## **Submission Objecting to State Significant Development (SSD-79261463)**

**1-3 Reid Street & 2-4 Woodside Avenue, Lindfield NSW 2070**

Figure 1: 400m distance

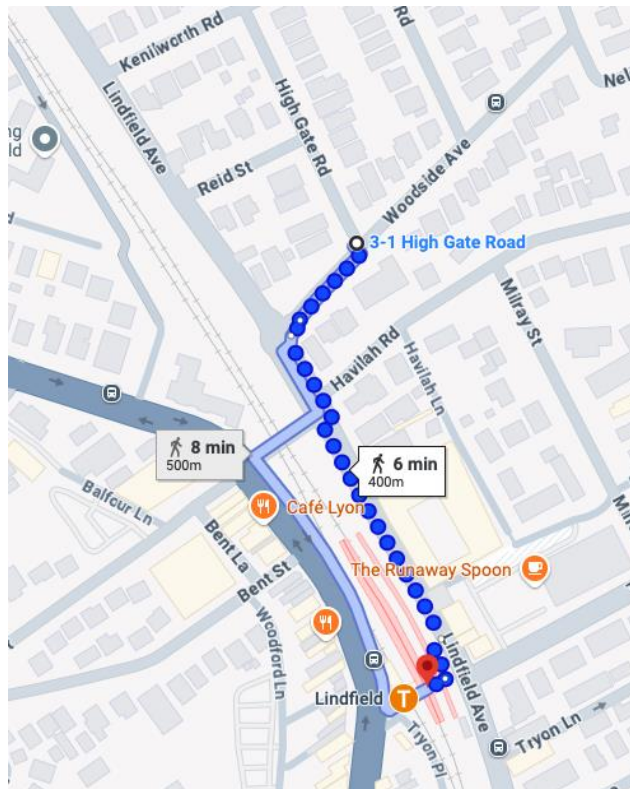
- **TOD Boundary Discrepancy:**
  - The site's inclusion wholly in the TOD area is questionable.
  - Measuring 400m *walking distance* from Lindfield Station's ticket office, only the southeast corner (Woodside/Highgate intersection) OR midpoint of Lindfield Ave boundary (the limit of 2 Woodside Ave block) qualifies. (see Figures 1 & 2 below)

- Under these measurements, Blocks 4–8 Highgate Road and 1–3 Reid Street lie outside the TOD boundary and should not fall under TOD planning.
